# Newmar Corporation Warranty Department

Technical Service Bulletin			
Date Issued	Model Year(s) Affected	Model(s) Affected	TSB #
6/16/09	2008	Diesel Pusher w/Oasis heat systems.	361
Brand		Type	
All <input type="checkbox"/>	Bay Star <input type="checkbox"/>	Canyon Star <input type="checkbox"/>	Grand Star <input type="checkbox"/>
Ventana <input type="checkbox"/>	Dutch Star <input type="checkbox"/>	Dutch Aire <input checked="" type="checkbox"/>	Mountain Aire <input checked="" type="checkbox"/>
Essex <input checked="" type="checkbox"/>	King Aire <input checked="" type="checkbox"/>	London Aire <input type="checkbox"/>	
<input type="checkbox"/> Air Conditioning & Heating <input checked="" type="checkbox"/> Appliances & Accessories <input type="checkbox"/> Cabinets & Furniture <input type="checkbox"/> Chassis Components <input type="checkbox"/> Construction Components		<input type="checkbox"/> Electrical Components <input type="checkbox"/> Exterior Components <input type="checkbox"/> Interior Components <input type="checkbox"/> Plumbing & Bath Components <input type="checkbox"/> Windows, Awnings, Vents, & Doors

Heating Systems	February 23, 2008	Bulletin Identification No.: MTB-111-11

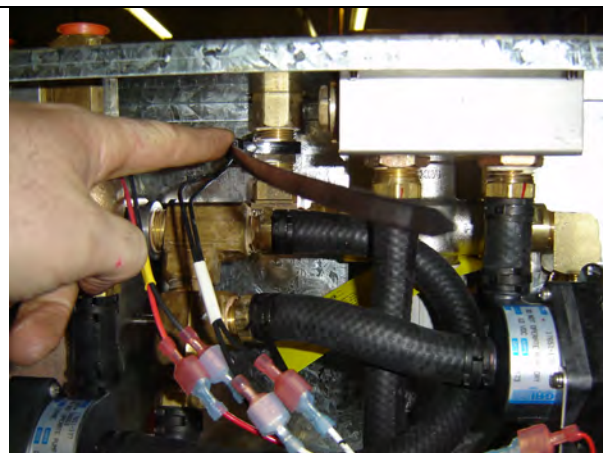
Place the aquastat back at a new location.  
On the vertical cold water inlet pipe.

It is recommended to add a tie strap to  
securely mount the aquastat in place.
